## Product Change Notification

**Date** February 23<sup>rd</sup> 2021  
**No.** 028-21

### TRACO POWER TEN 40E and TEN 40WIE series

#### Base plate preparation for additional heatsink mounting options

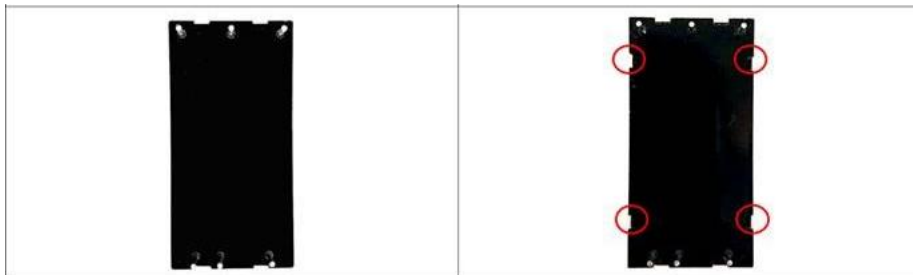
Subject product series have undergone a minor package design change. To be able to mount additional heatsink options the base plates of the TEN 40E and TEN 40WIE now received four additional slots for mounting clamps on the long sides.

Phased out package design

New package design

The exact positions of the new slots can be seen on the updated 3D-files online on our website: [www.tracopower.com/overview/ten40wie](http://www.tracopower.com/overview/ten40wie)
